UPPER AUSTRALIA PRECINCT – MOD 2 – RESPONSE TO SUBMISSIONS

This Response to Submissions Report (RtS) has been prepared by Urbis on behalf of Taronga Conservation Society Australia (TSCA, the Applicant) in response to submissions received during the public exhibition of the proposed modification to State Significant Development (SSD) Development Application for the Upper Australia Precinct, Taronga Zoo (SSD-10456-Mod-2).

Figure 2 Views of Upper Australia Precinct

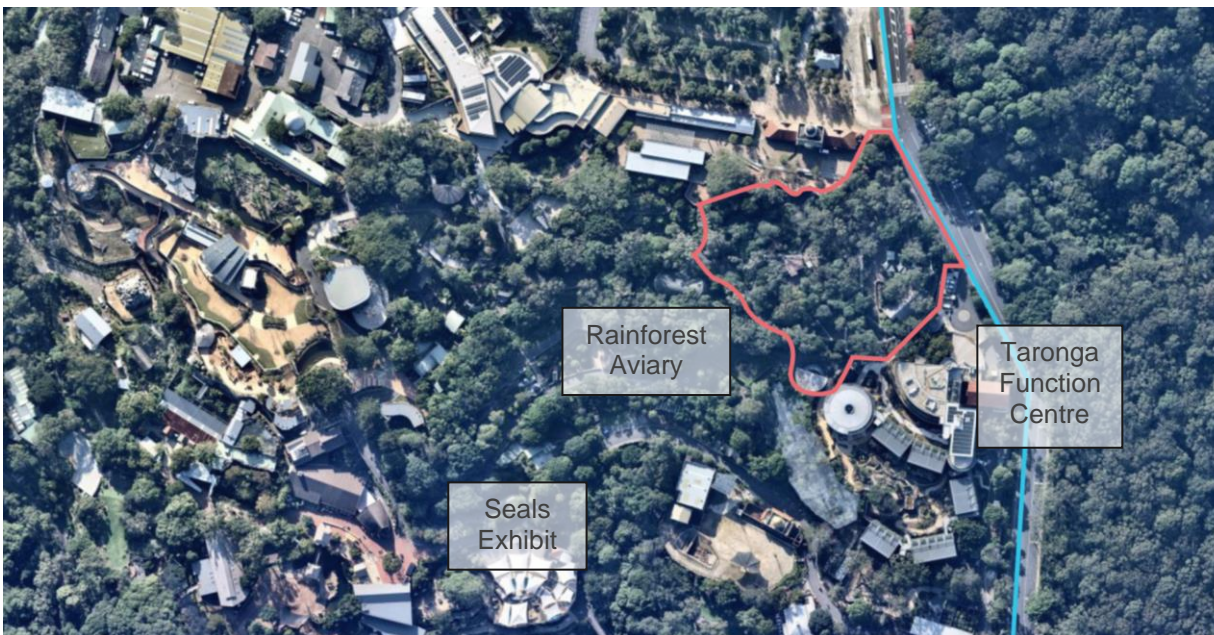
- A condition should be imposed to ensure that the reflectivity and visibility of the roof is minimised.

The overall built form remains **within the tree canopy** and is not visible from Sydney Harbour as shown in **Figure 2**. Large, mature trees surround the site including the Rainforest Aviary which is identified as part of the local heritage item 34 under the *Mosman Local Environmental Plan 2012*. Given the heritage significance of the Rainforest Aviary, the tree canopy located in front of the Upper

While the overall reflectivity of the roof is difficult to measure numerically, based on the location and design of the development, the approved Koala Treehouse will not be visible or impact views from Sydney Harbour or neighbouring properties. Overall, the approved development has been designed to minimise glare and the numerical control is not relevant for the site. The proposed modification continues to request the removal of Condition B7.
